Proposal for Supplement 6 to the 04 series of amendments to Regulation No. 48
(Installation of lighting and light-signalling devices)

Note: The text reproduced below was prepared by the experts from Japan in order to divide the documents into the AHS (Automatic Headlamp Switching) requirements and the other requirements. The proposal is based on ECE/TRANS/WP.29/2010/23, Corr.1 and WP.29-150-02. The modifications to ECE/TRANS/WP.29/2010/23, Corr.1 and WP.29-150-02 are marked in **bold** or ~~strikethrough~~ characters.

VISIBILITY OF CONSPICUITY MARKINGS TO THE REAR, FRONT AND
SIDE OF A VEHICLE

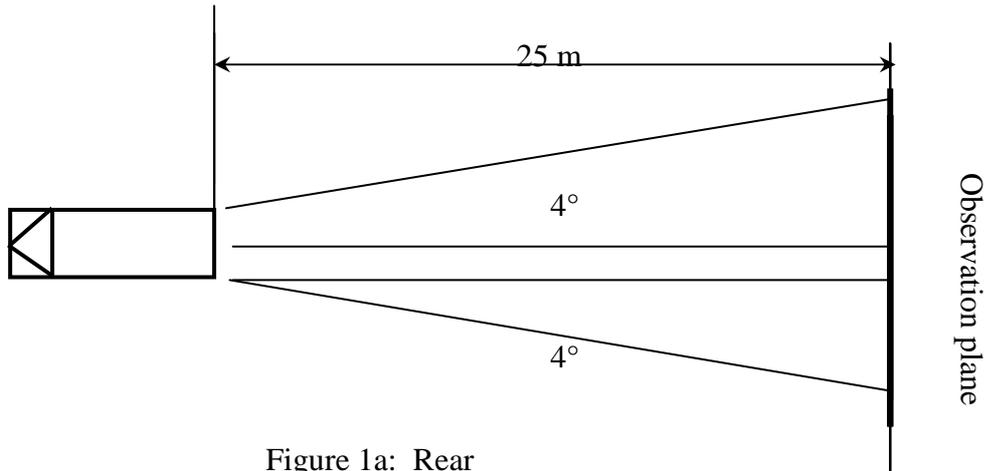
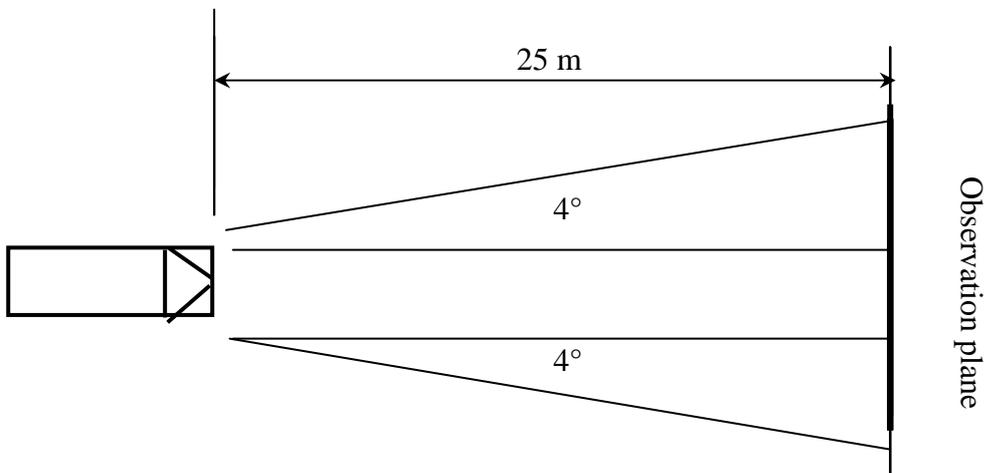
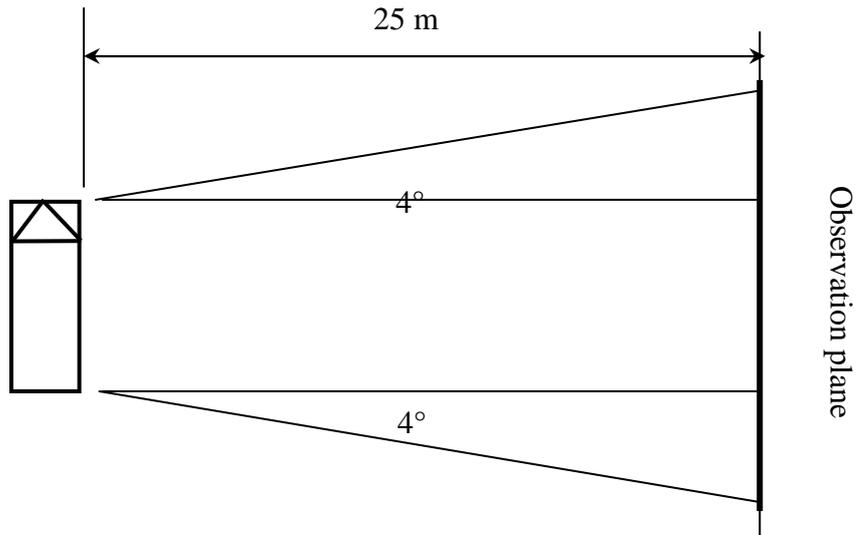
Annex 11, amend to read:

"Annex 11
